**Subject: ITB #2584-B: Justice Center Buildout - Construction
Addendum #1**

Renovation of Fayette County Justice Center

1.1 ADDENDUM

FIRST FLOOR
PLAN
NEW WORK

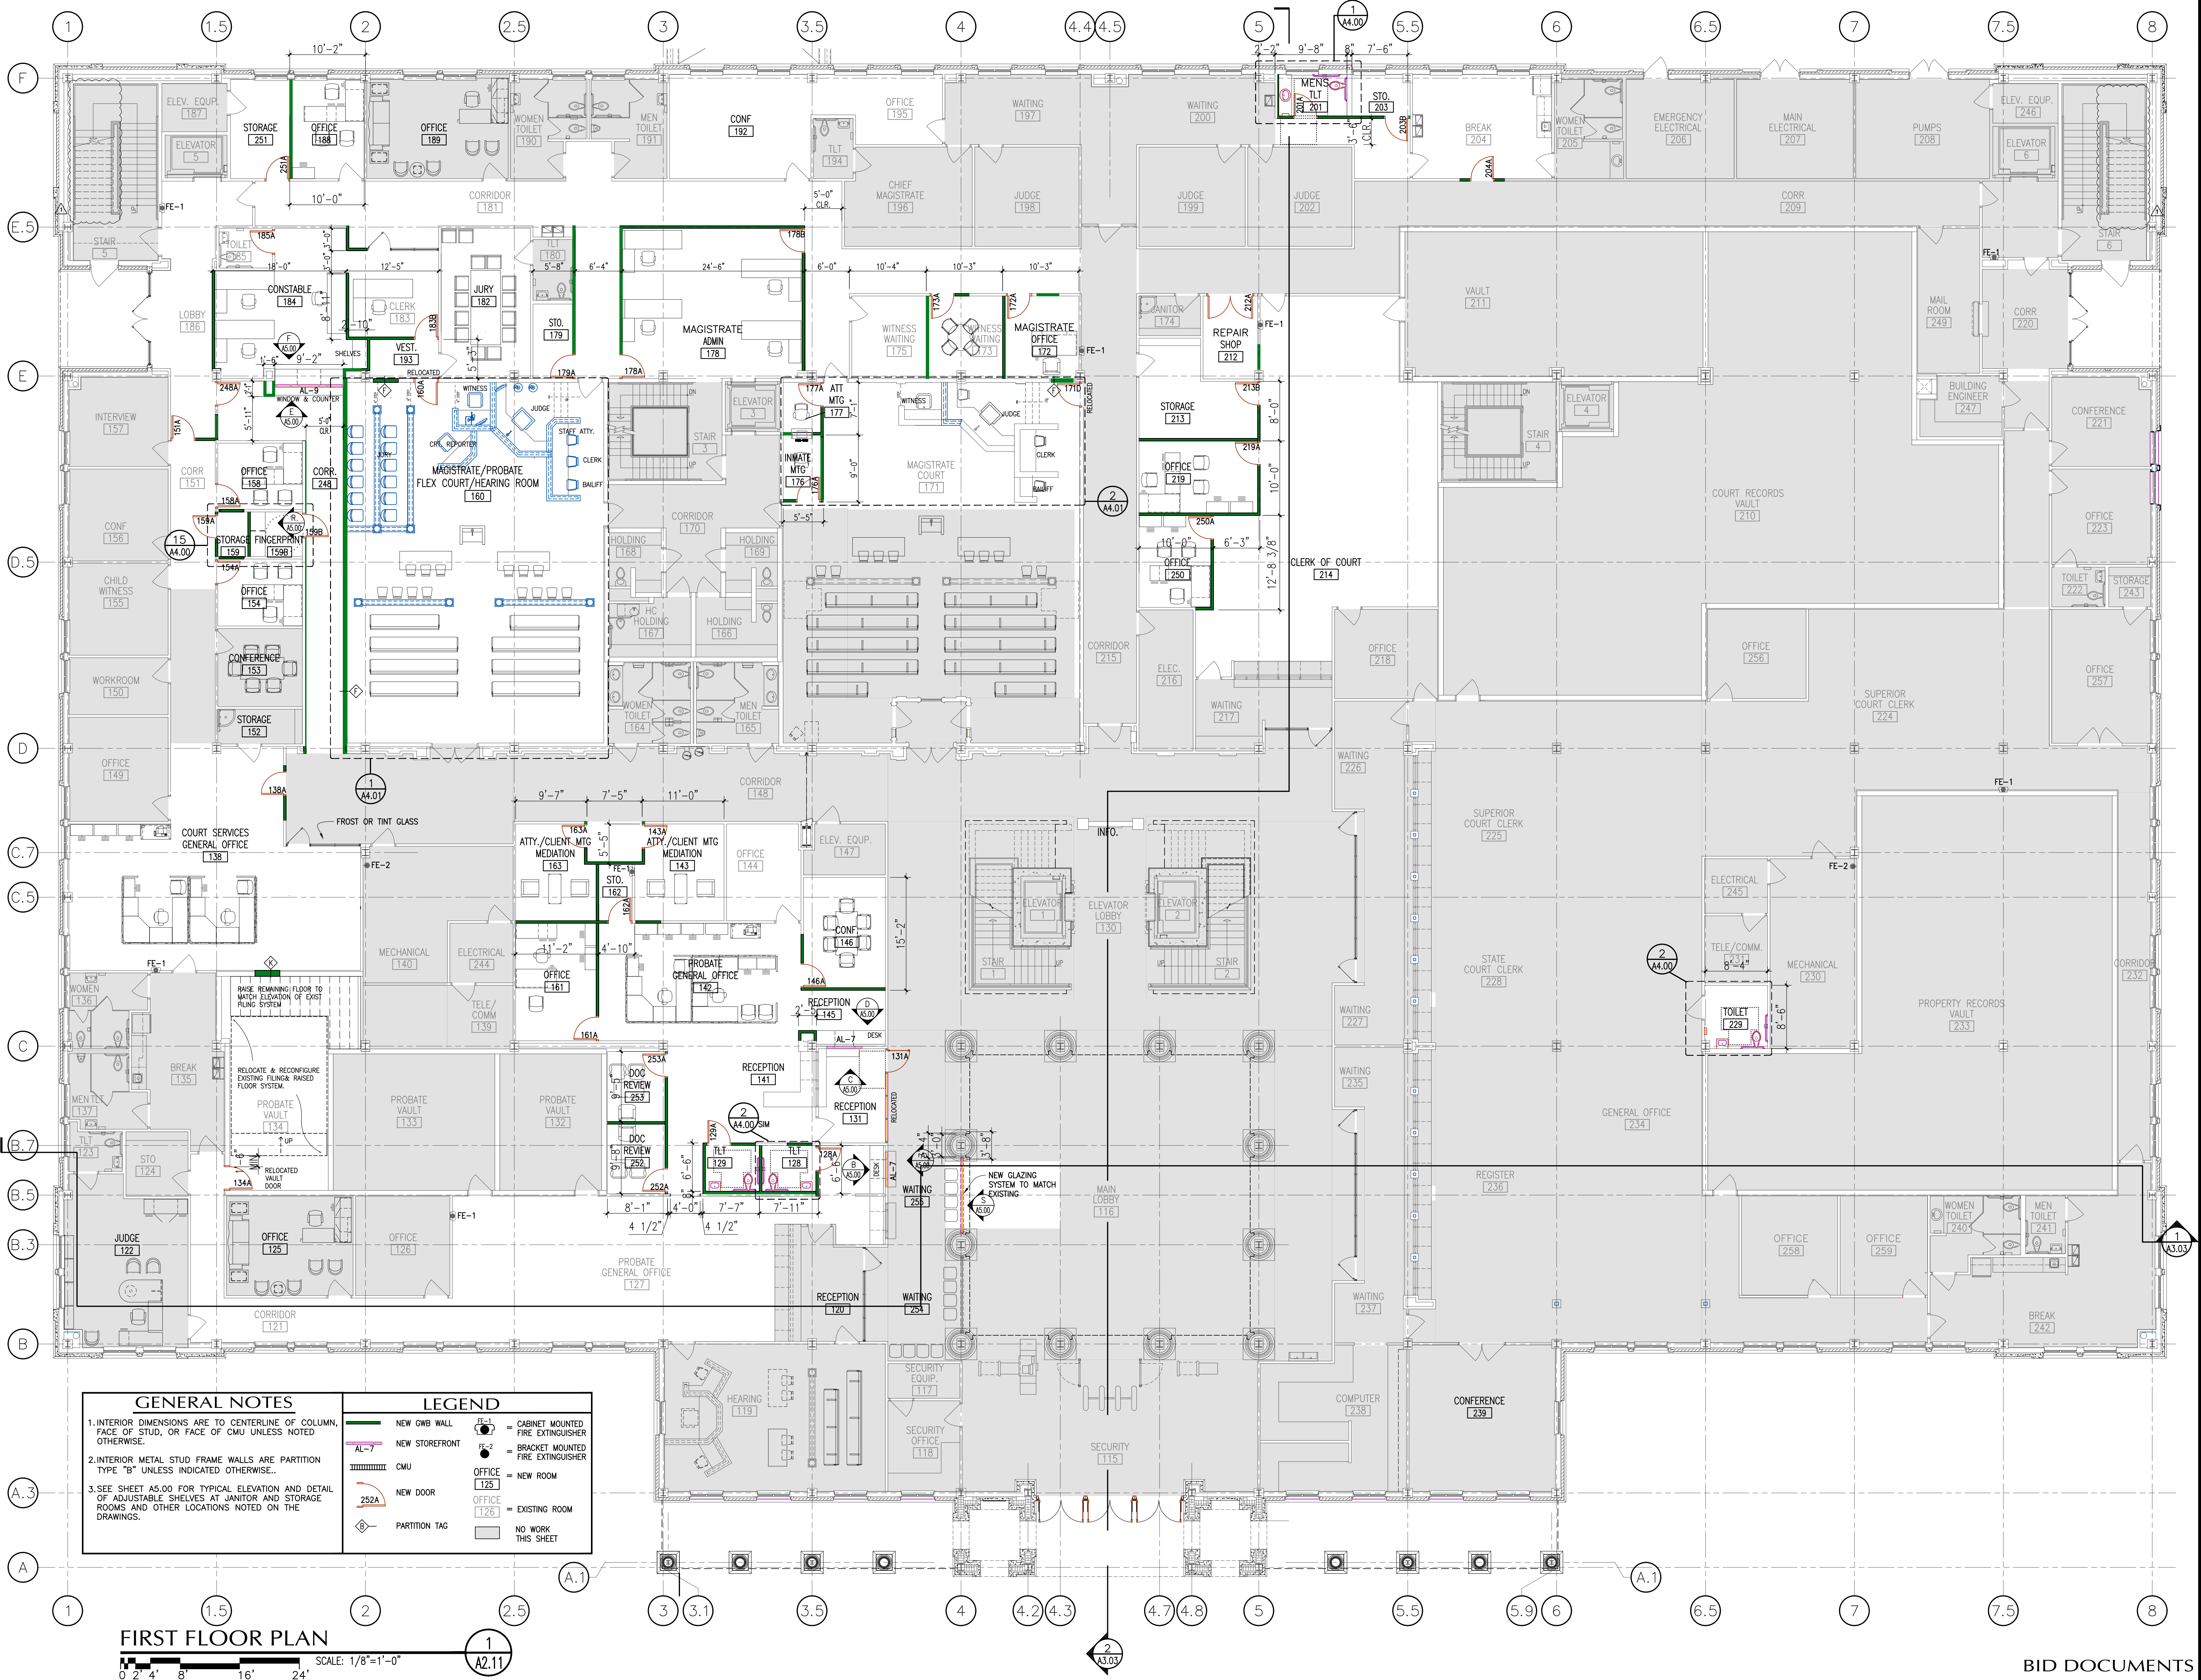
43. Equipment Storage Room # 261 – This room is shown at stair #6 on the first floor. Currently there are not any demo plans to accommodate the room. Please confirm the location and layout. **This storage room is a potential safety hazard and must be removed from scope.**

44. Equipment Storage Room # 260 – This room is shown at stair #5 on the first floor. Currently there are not any demo plans to accommodate the room. Please confirm the location and layout. **This storage room is a potential safety hazard and must be removed from scope.**

- A. Sheet A2.11 – First Floor Plan New Work (reissued).
 - 1. Delete all work at closets under stair, Equipment Storage 260 & 261. Remove doors 260A & 261A.
- B. Sheet A4.12 -Door Schedule (reissued).
 - 1. Removed doors 260A 261A.
 - 2. Existing frames changed to new HM frame at 131A, 134A, 160A, 171D
- C. Sheet A4.14 Aluminum Frames & Storefront (reissued).
 - 1. Added storefront type AL-7 which is located First Floor 176-177 Client /Attorney meeting rm. Added safety glazing locations to storefront types
- D. Sheet A5.00 Interior Elevations – (reissued).
 - 1. P/A5.00 modified detail per P.2/A5.00
 - 2. P.2/A5.00 section (added)
- E. Sheet A5.03 Courtroom Sections – (reissued).
 - 1. Added callout 11/A5.04 to section 4/A5.03
- F. Sheet A5.04 Courtroom Details – (reissued).
 - 1. 11/A5.04 crown moulding and apron detail (added).
 - 2. Fixed detail 1/A5.04 scale.

ALUMINUM
FRAMES &
DETAILS

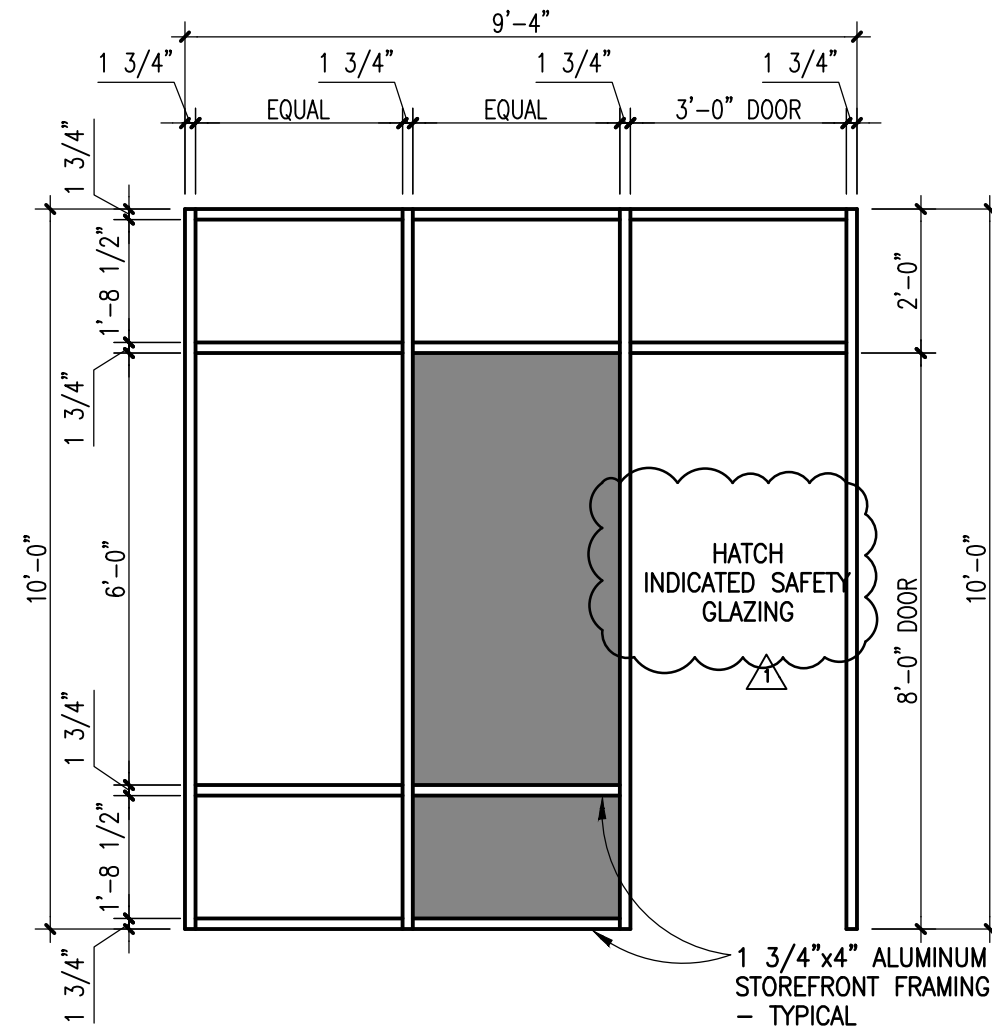
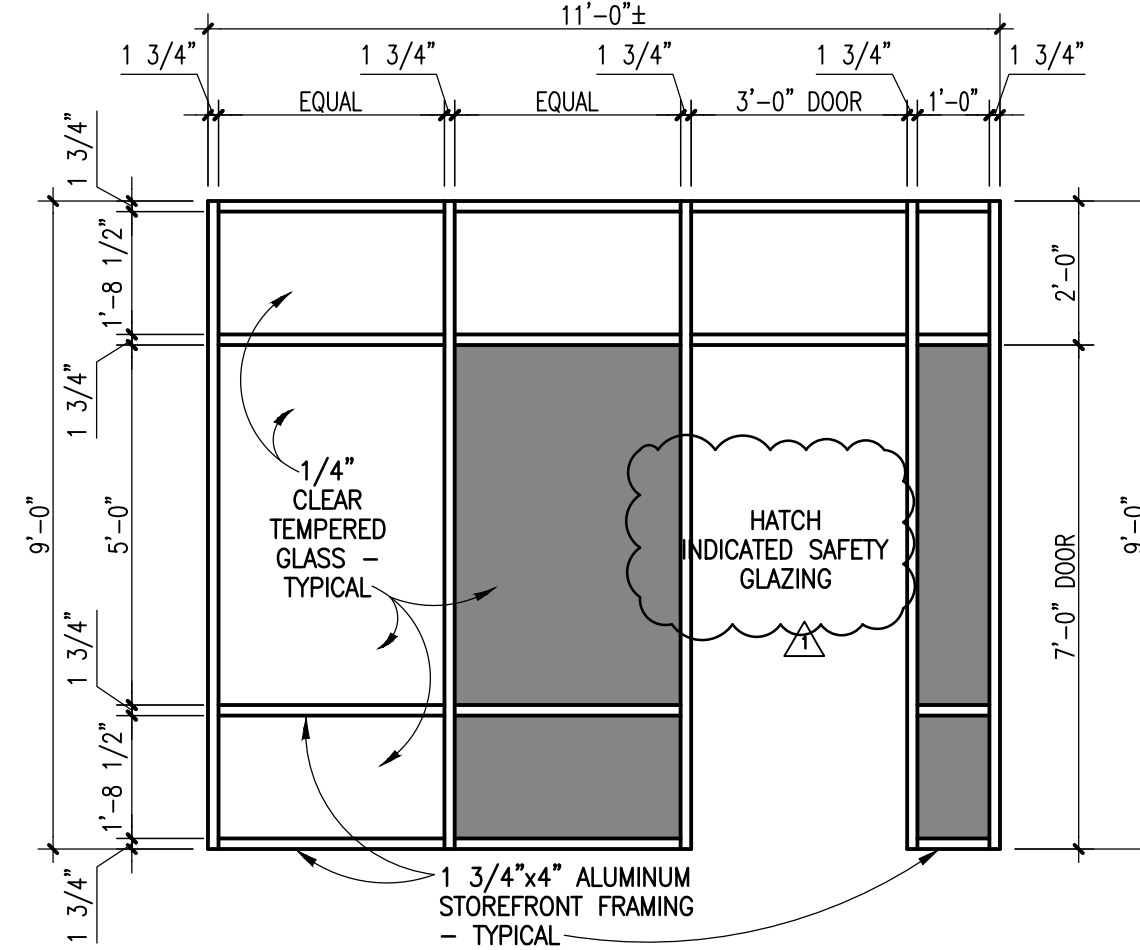
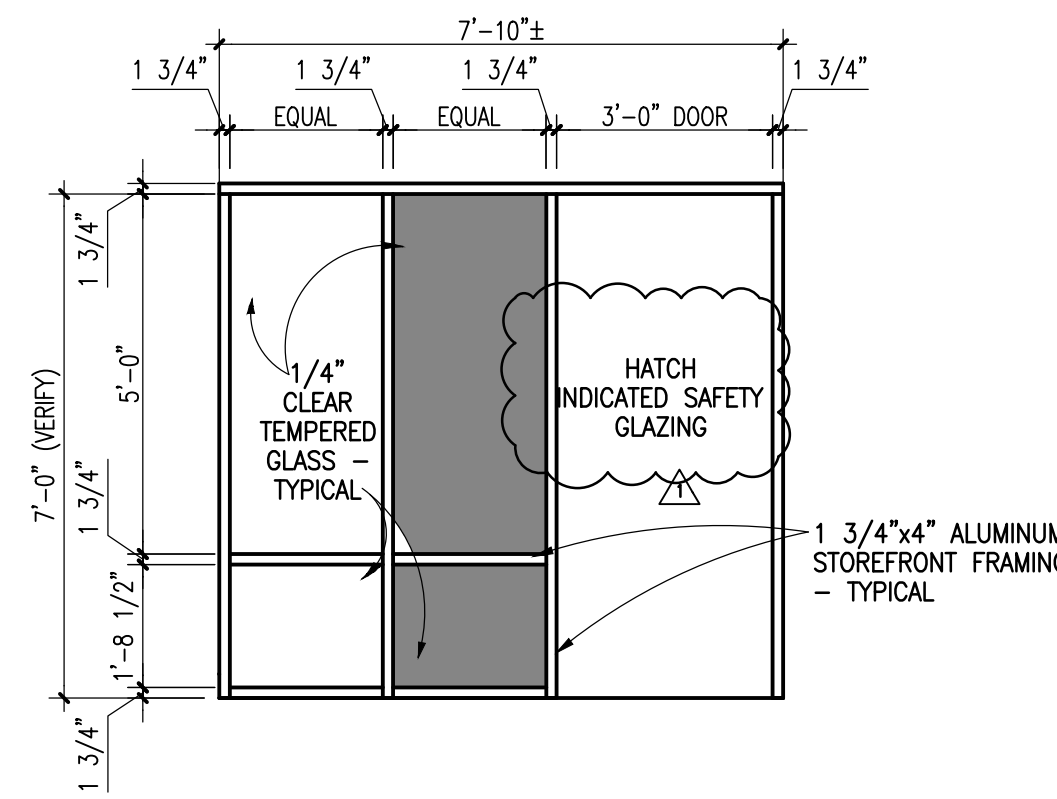
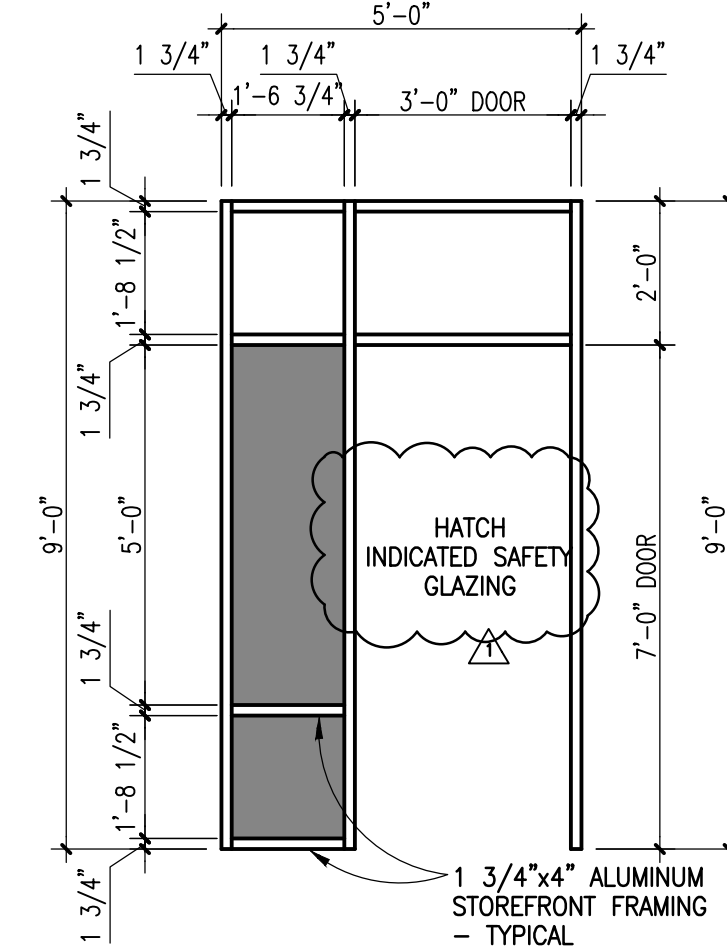
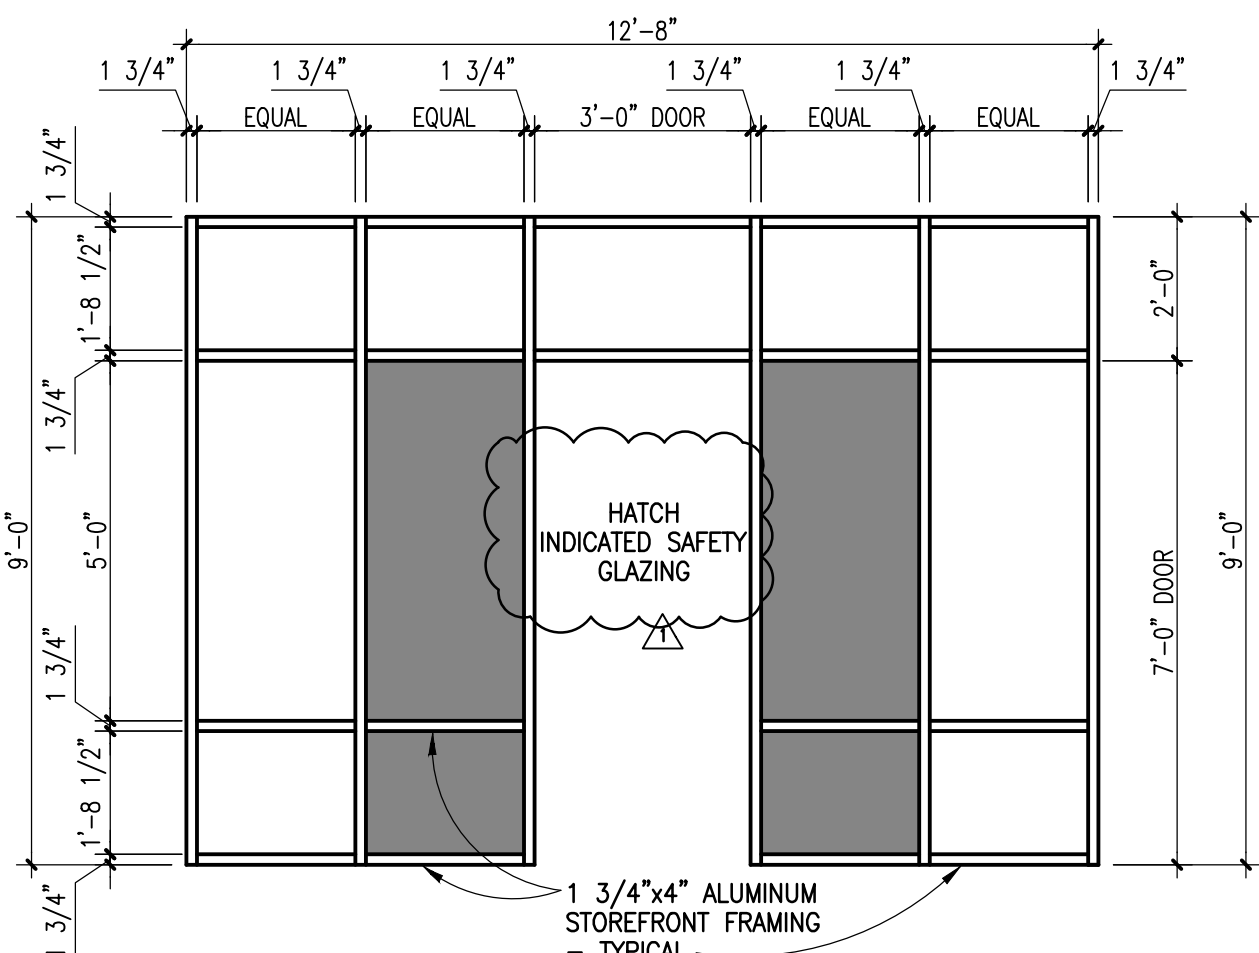
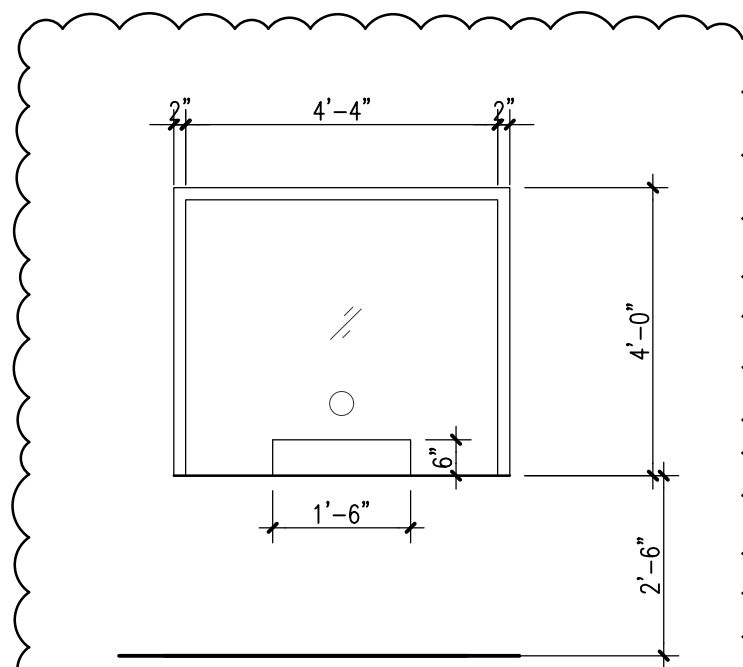
81. The specifications contain sections on Security Glass & Glazing (088853) and Security Hollow Metal Doors and Frames (083643). Please confirm if any of the aluminum storefront elevations are to have security glazing. **Confirmed. Added locations to storefront types A4.14.**

AL-1
GLAZING THIS ELEVATION IS 1/4" CLEAR TEMPERED GLASS, TYPE G-2, UNLESS NOTED OTHERWISE.

AL-2
GLAZING THIS ELEVATION IS 1/4" CLEAR TEMPERED GLASS, TYPE G-2, UNLESS NOTED OTHERWISE.

AL-3
GLAZING THIS ELEVATION IS 1/4" CLEAR TEMPERED GLASS, TYPE G-2 UNLESS NOTED OTHERWISE.

AL-4
GLAZING THIS ELEVATION IS 1/4" CLEAR TEMPERED GLASS, TYPE G-2 UNLESS NOTED OTHERWISE.

AL-5
GLAZING THIS ELEVATION IS 1/4" CLEAR TEMPERED GLASS, TYPE G-2 UNLESS NOTED OTHERWISE.

AL-6
GLAZING THIS ELEVATION IS 1/4" CLEAR TEMPERED GLASS, TYPE G-2 UNLESS NOTED OTHERWISE.
